## Draft Final Modification Report

# GC0148: 'Implementation of EU Emergency & Restoration Code Phase II'

*Figure 1.0 Shows the performance requirements expected from an electricity storage module transitioning from an import mode of operation to an export mode of operation.*

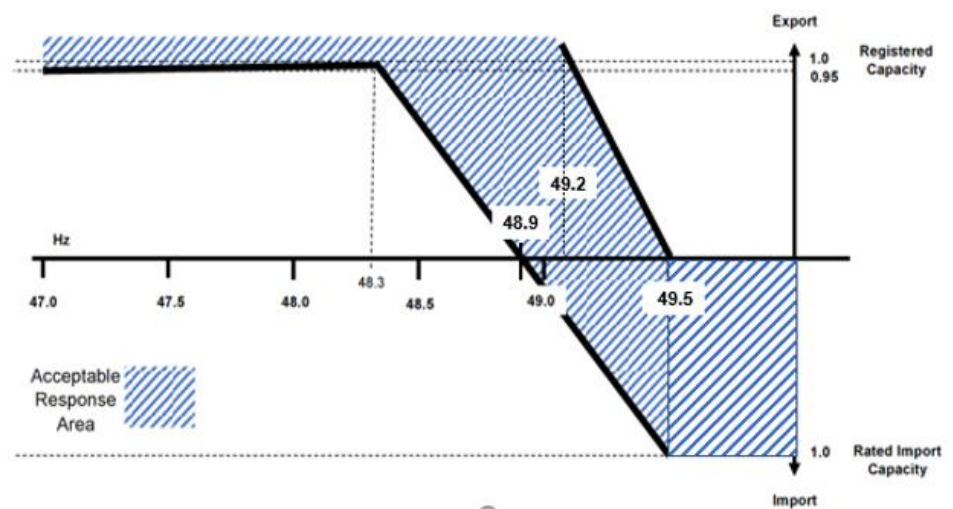
A Workgroup member noted that the suggested approach necessitated by article 15(3) would be erroneous, in their view, in terms of ensuring legal compliance as the wording (in the article and the NCER) applies both to new and existing electricity storage modules. The proposer noted this issue and stated that in the proposer's opinion article 15(3) requires a deload capability from import to export (article 15(3)(a)), however, where a plant is unable to meet this requirement then article 15(3)(b) a trip function applies. This has been codified within the legal text in Annex 8 and is believed to have addressed this issue.
